Planning Commission

November 19, 2024 6:00 PM,

1. **Planning Commission Minutes – October 29, 2024**
2. **Case 24-320-08 – Final Plat – McBee Acres** – A request for Final Plat approval for McBee Acres generally located at the northwest corner of US 24 and Salem Drive.

CASE NUMBER/REQUEST: **24-125-05 - 19300 E. 37th Terrace S.** – A request by JC Weston Construction to rezone the property from C-2 (General Commercial) to R-30/PUD (High Density Residential/Planned Unit Development) and approving a preliminary development plan

SHEET NO.
C200

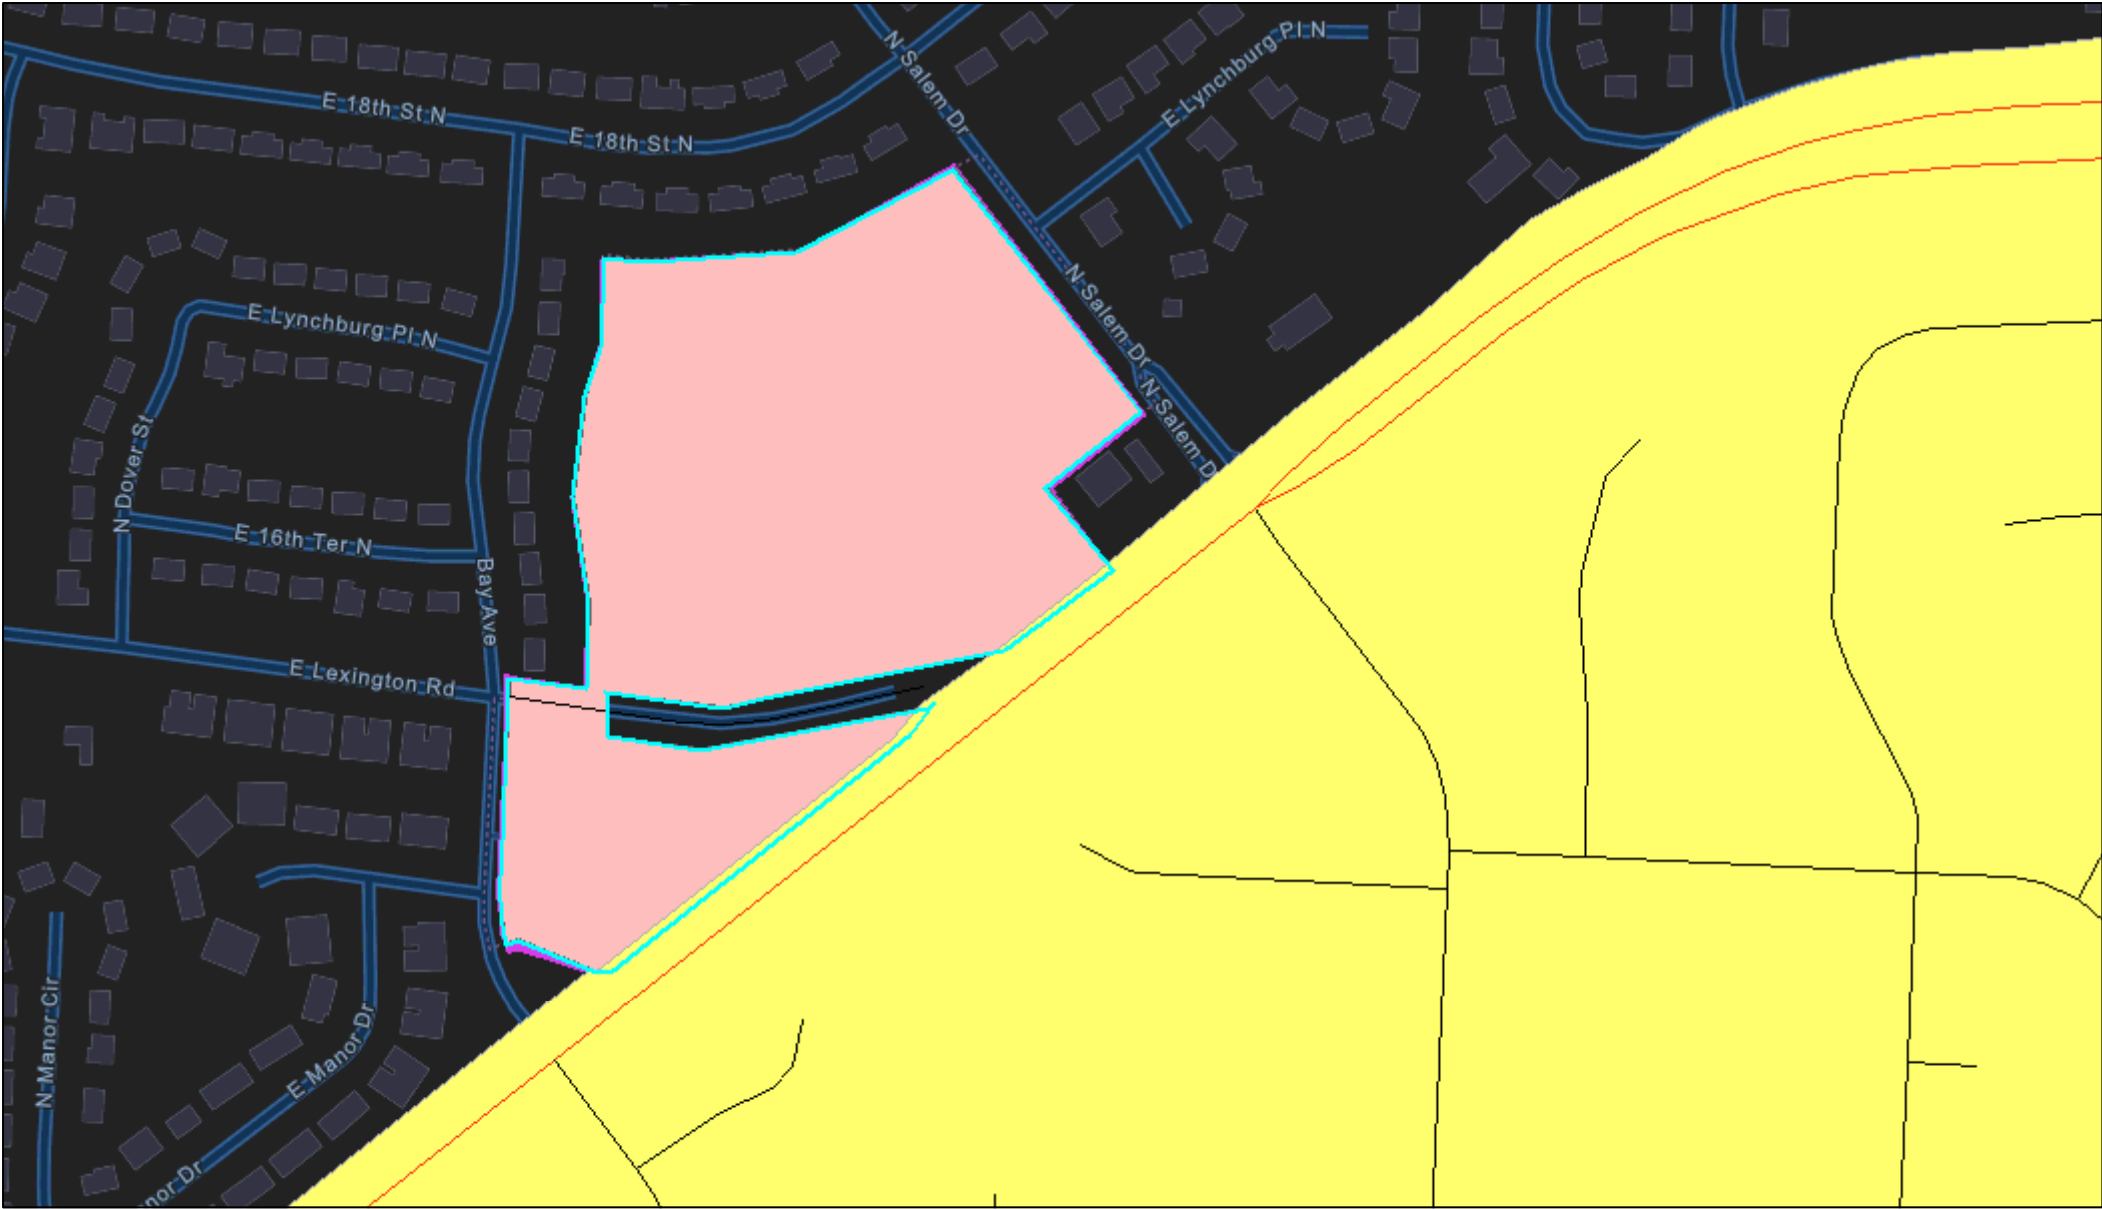
1. Correct addresses based on attached address exhibit (Exhibit A).
2. Label the loop street on the northern and western, "E. Lynchburg Place N.", and, the southern and eastern part of the loop, "E. 16th Terrace N.". Change "S. Salem Dr." to "E. 16th Terr N.".
3. Remove the lot line (solid line) at the intersection of E. Lynchburg Place N. and N. Salem Drive. The Right-of-Way should be continuous, without breaks.
4. Change "Block 1" and "Block 2" to "Lot 1" and "Lot 2". This change will need to be reflected in the drainage easement language.
5. Language regarding the maintenance of drainage easements will need to be reviewed by Staff to verify concurrence with the recorded covenants.
6. Please indicate/delineate the boundaries for Drainage Easement "A". Ensure that the boundaries of Drainage Easement "B" match the Preliminary Development Plan. These

8. Remove 25' Building Line (Note: varied exterior setbacks and minimum 20' rear yard setbacks will need to be indicated on Final Development Plan, in accordance with the approved Preliminary Development Plan #22-125-01).

9. Submit Final Development Plan prior to construction. Final Development Plan is required to be submitted in accordance with City Code 14-703-06 and can be processed concurrently with Building Permit application(s).

DRAWING NO.
C200

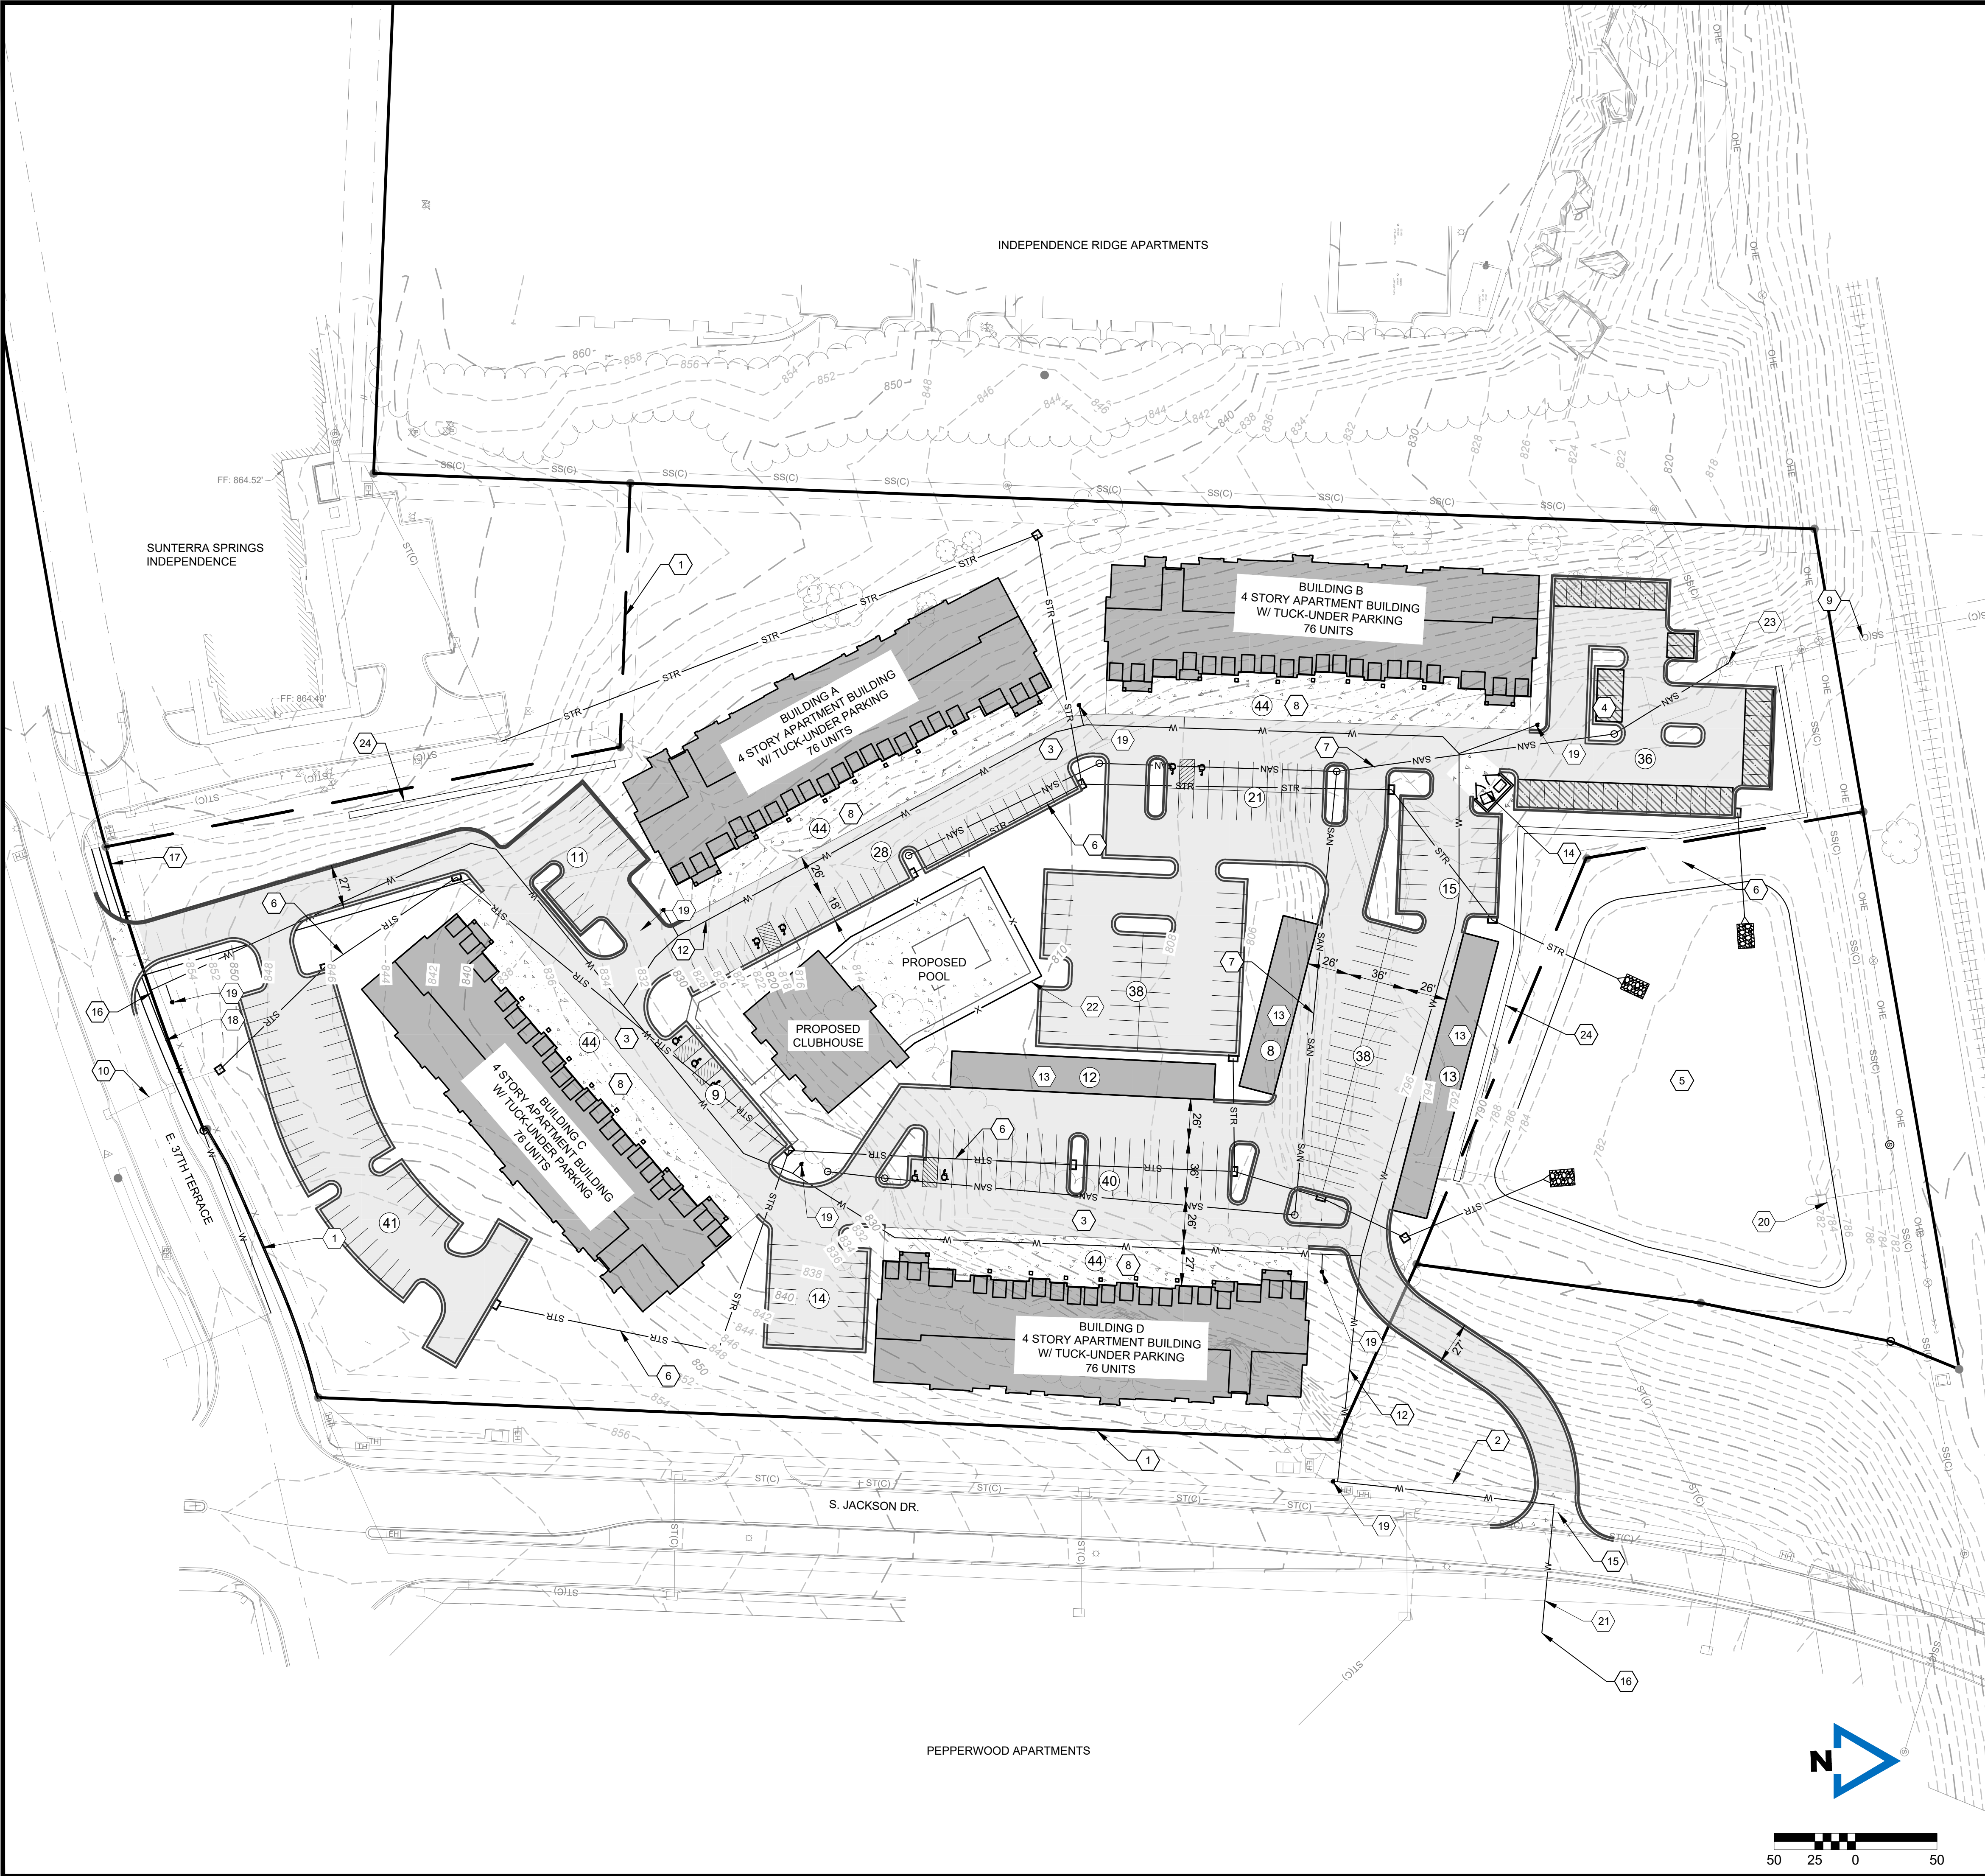
1. A building setback deviation shall be granted for the easternmost building (i.e., Building D) to allow the building to be set back 16 feet from the Jackson Drive right-of-way instead of 50-feet.
2. A building height deviation shall be granted for the easternmost building (i.e., Building D) to allow the building may be as high as 50-feet tall on the non-garage side and 60 feet tall on the garage side.
3. In exchange for the building height and building setback deviations, the significant landscaping as shown on the landscape plan shall be provided.
4. The applicant shall provide an additional amenity in addition to the pool and clubhouse. Staff will work with the applicant to ensure that amenities are provided at the final development plan stage.

It should be noted that the site plan shows a full-access driveway that would require a median break along Jackson Drive. Although a northbound left-turn lane is not warranted due to traffic volumes at this intersection, a median break without a dedicated turn lane is not recommended as drivers would not be expecting a left-turn driver slowing down to make the turn on a divided roadway without a left-turn lane present. There is an existing bridge just north of the intersection and a significant retaining wall on the east side of Jackson Drive that would make it difficult to construct a northbound left-turn lane. If a dedicated left-turn lane is not feasible, the driveway access should be limited to right-in/right-out access.
